**MUNICIPAL CORPORATION
KARACHI.**

Re: Plot No. 103. M.M.6.

AMENDED
PLAN SHOWING PROPOSED ADDITIONS & ALTERATIONS ON PLOT N: 103. SHEET N: M.M.6.
MACHIT MIANEE QUARTER
Scale 8 1/2" = 1" = 10' INCH

With reference to your application dated 13th February 1939 with a plan for the proposed buildings/additions and alterations on plot No. 103 Survey Sheet No. M.M.6, Machi Meani Quarter, I have to request you to comply with the following requirements:—

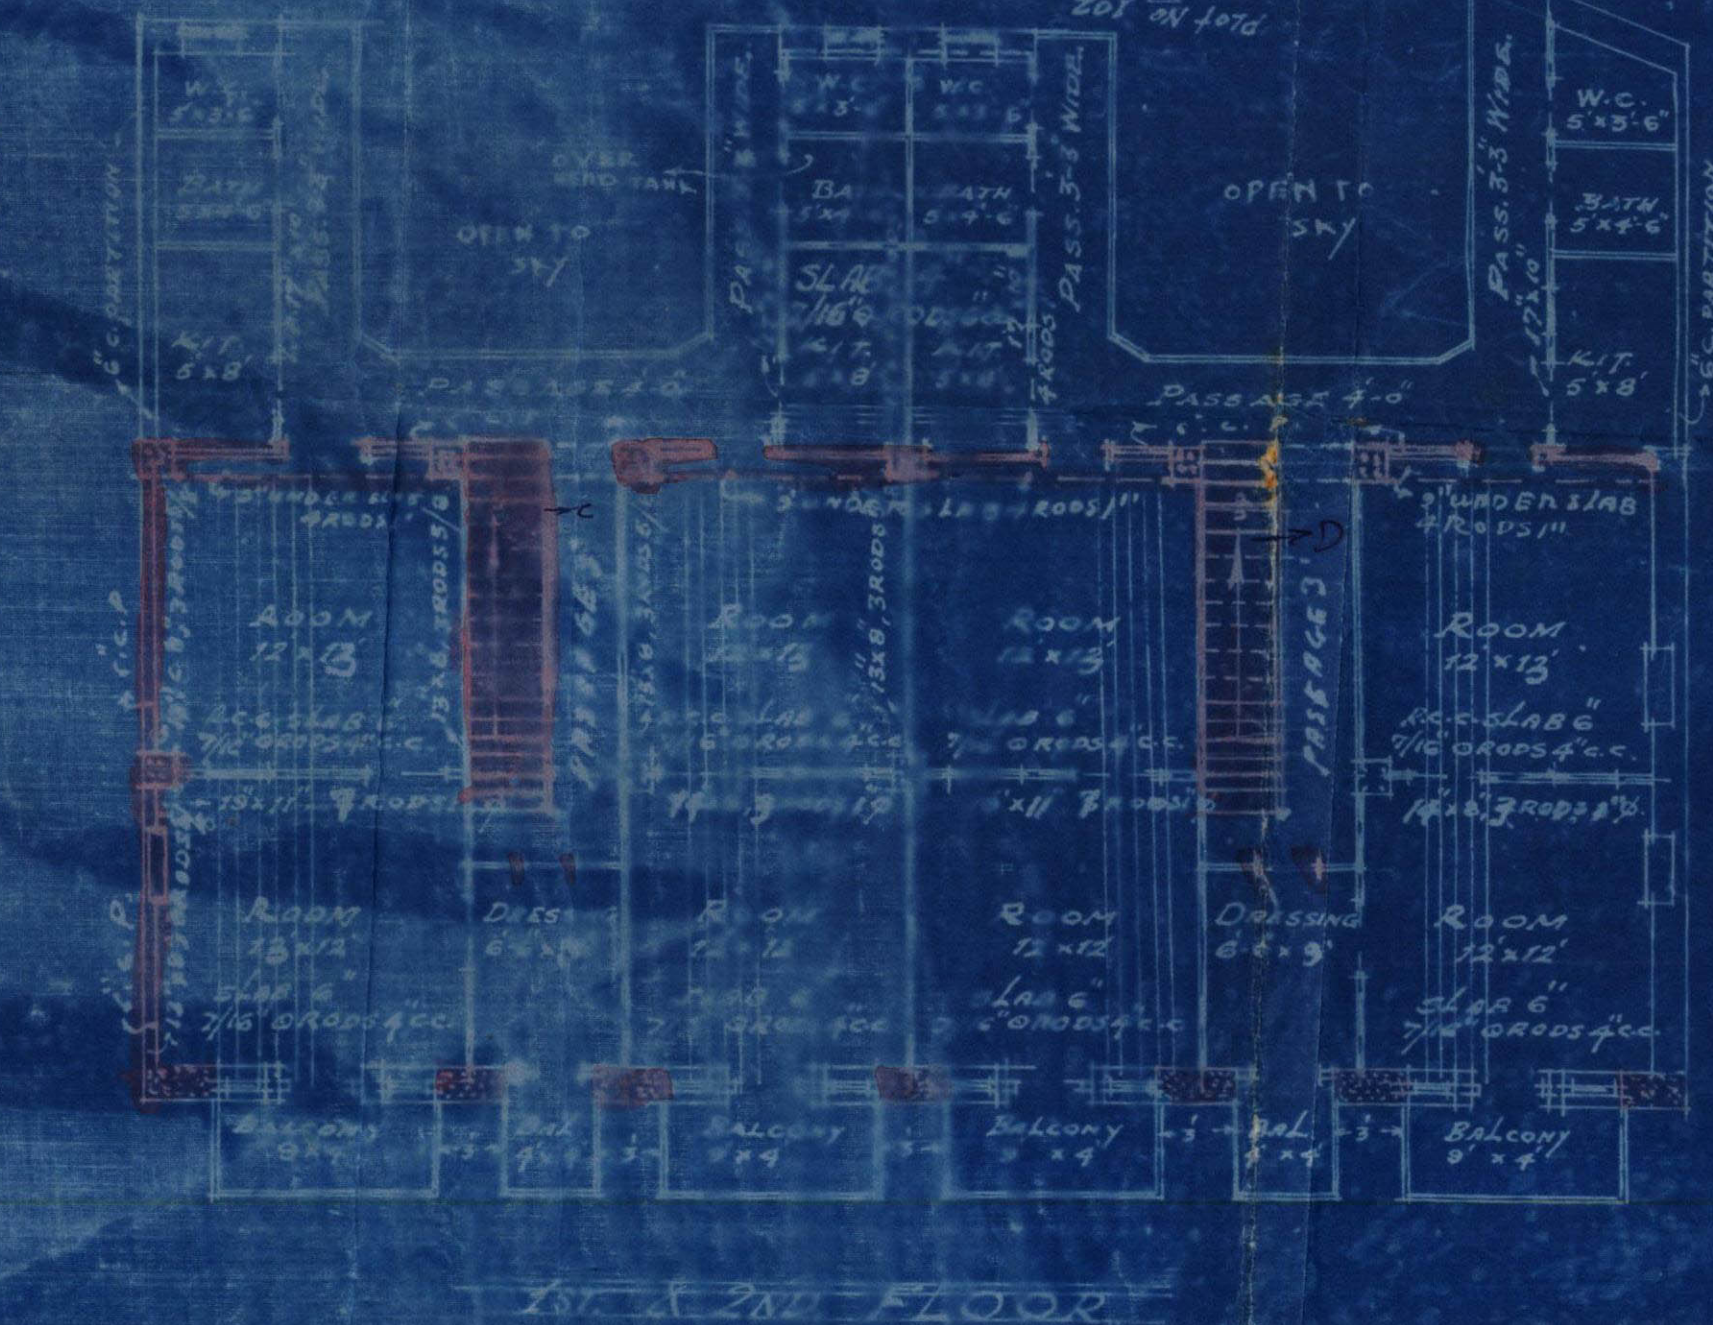
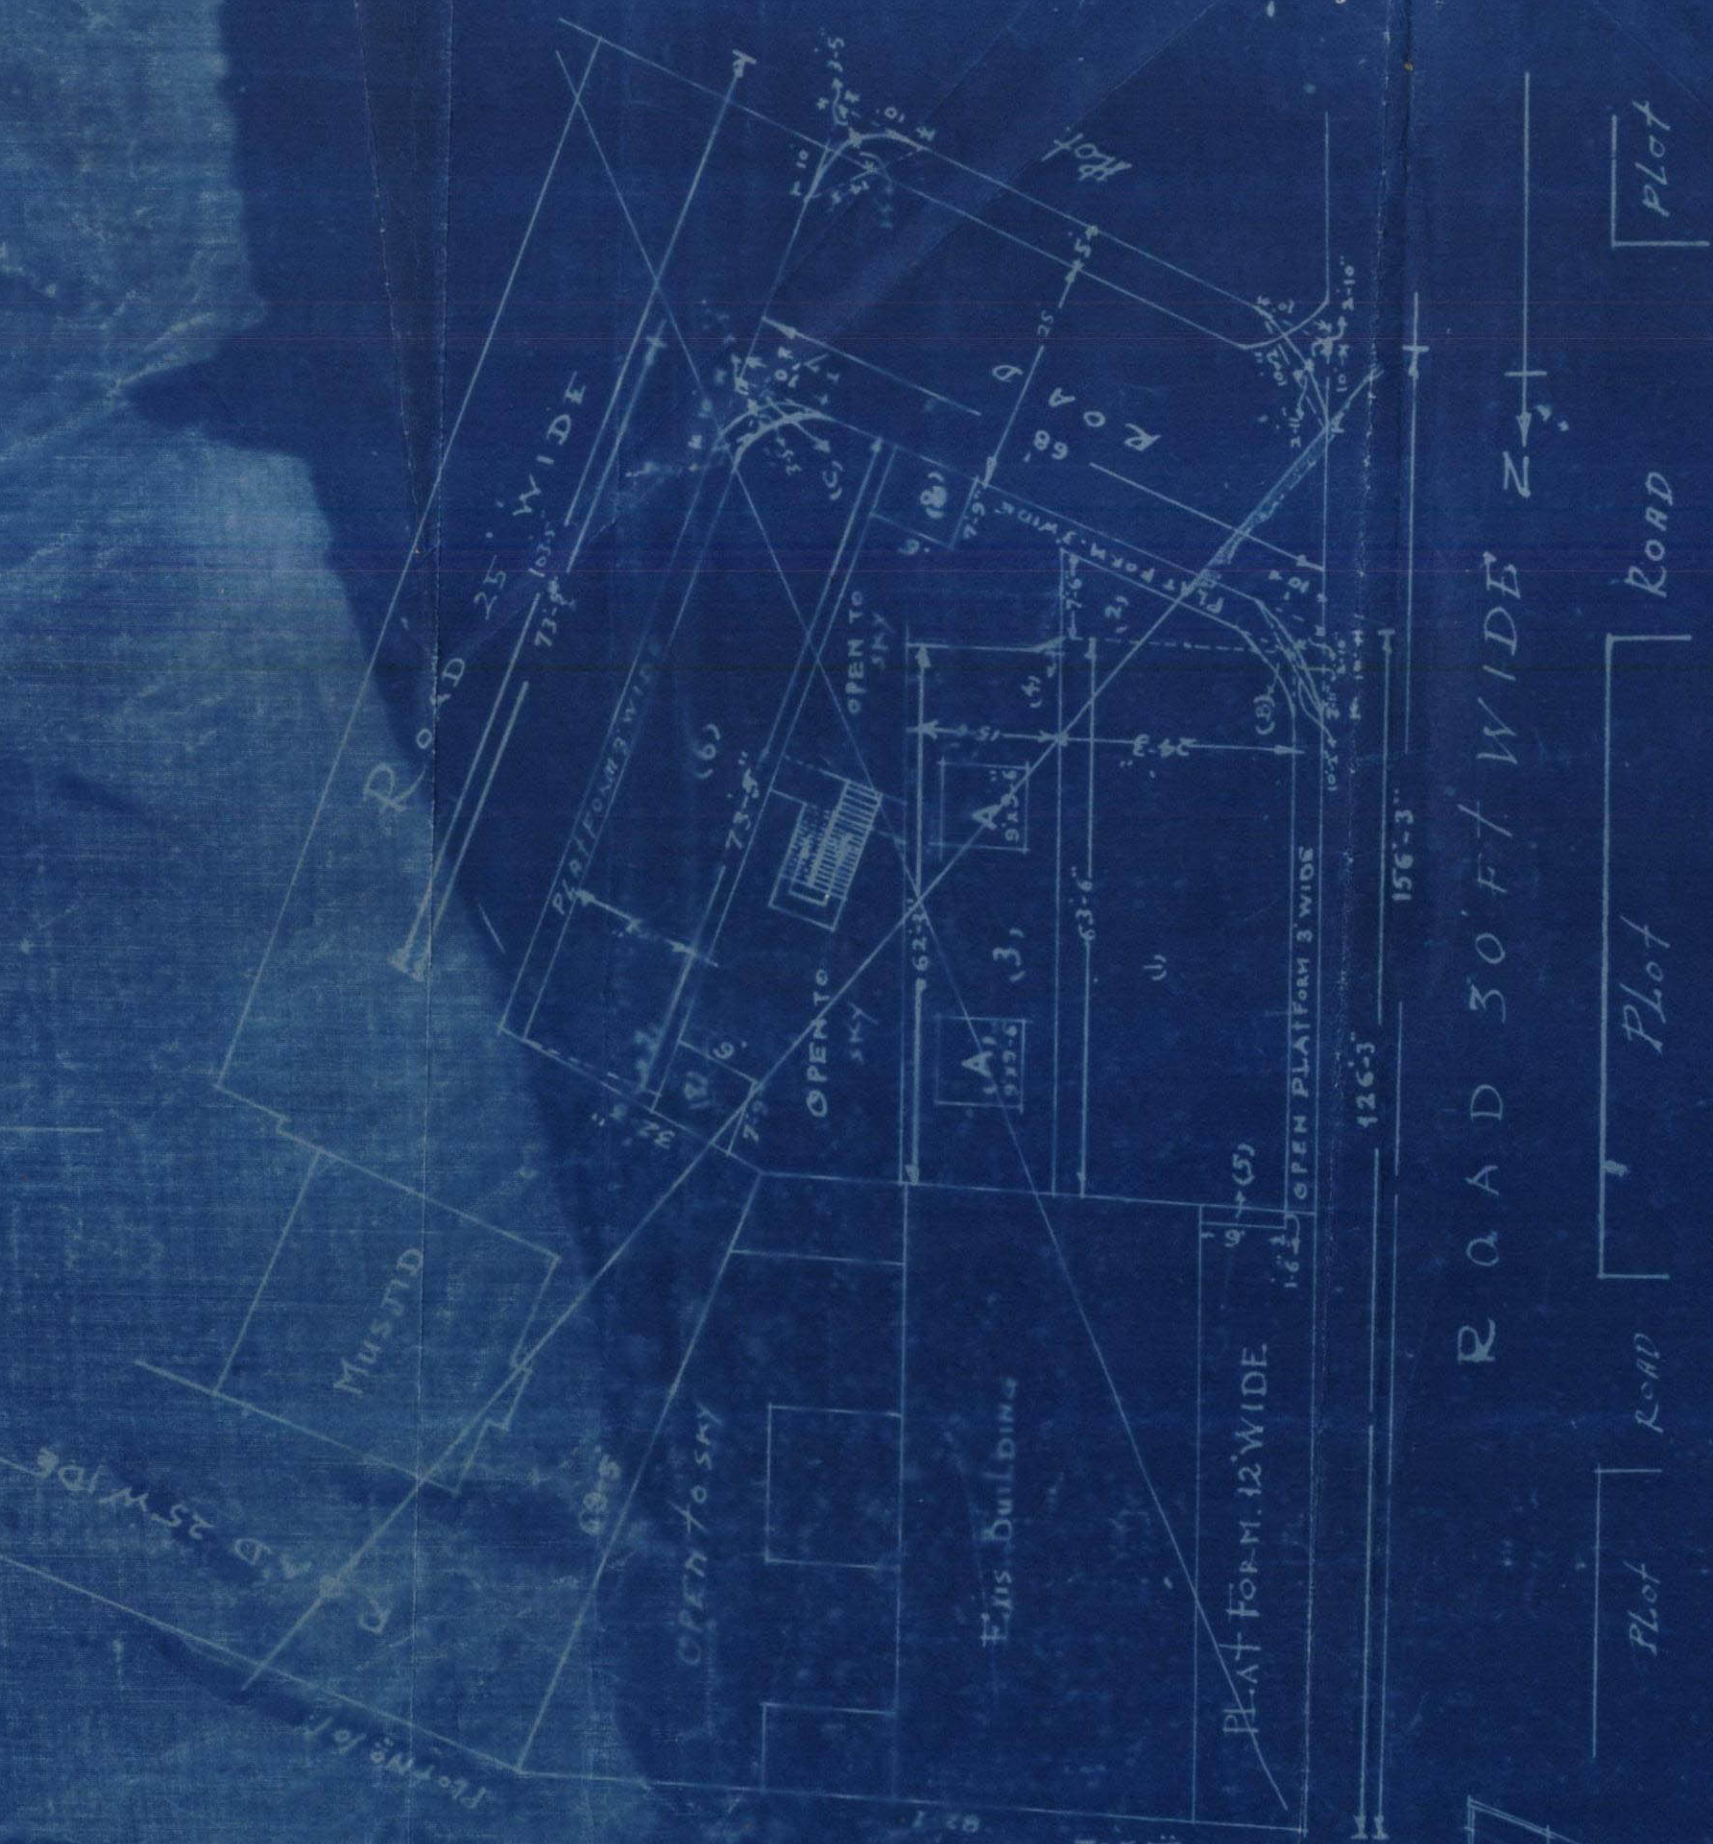
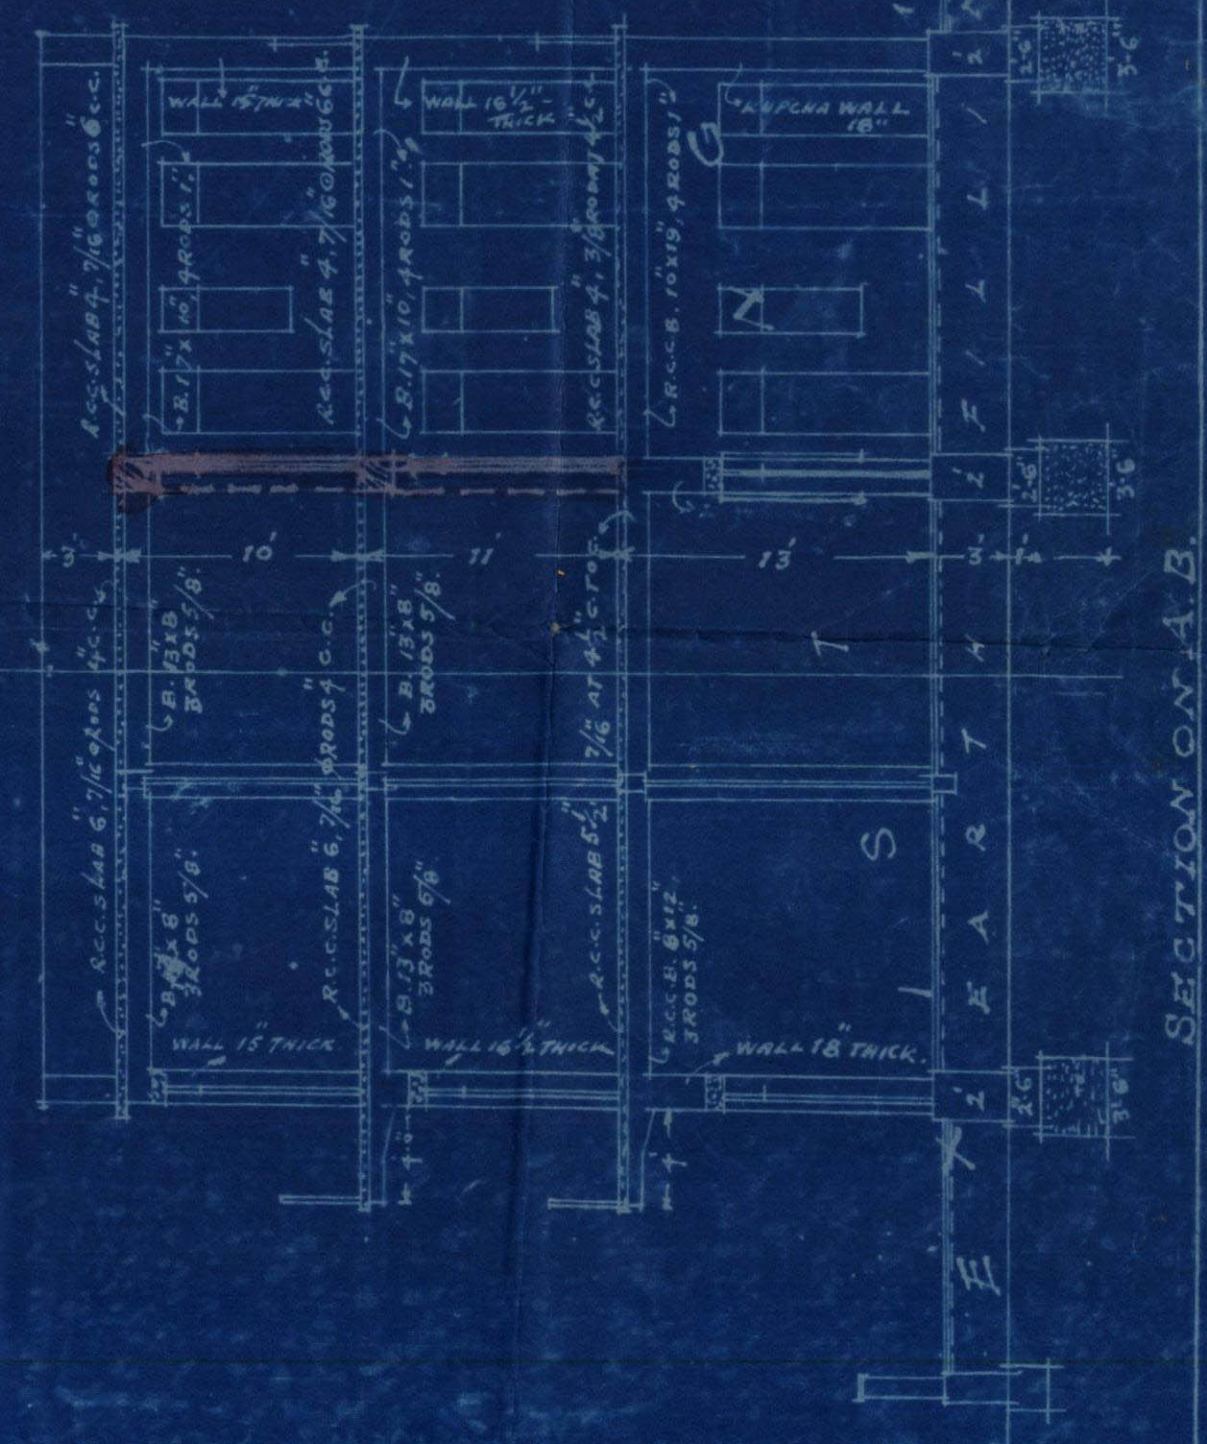
1. It is not understood why a bath $21' \times 13'$ is required
2. The so called veranda on upper floors over the bath mentioned in (1) is a small room which is against the rules
3. Dimensions of the rooms though increased by adding verandas are not changed in the plan submitted.
4. Section requires correction.
5. Windows be provided to the W.Cs towards the open to sky spaces as required under the rules
6. Built up area calculations be correctly given as per detail plan - measurements of built up area ~~and~~ open area have to be jointly verified for which the architect should keep an appointment with the B.S.
7. Distances between every two balconies be given on the plan.
8. All deletions to be coloured yellow
9. Pillars encroaching on the open to sky space will be taken in built up area.

With reference to your letter dated 16th June 1939
re: R.C.C. roof filling, you are requested not to do so,
as you have not got your amended plan approved and more-
over there is question of built up area.
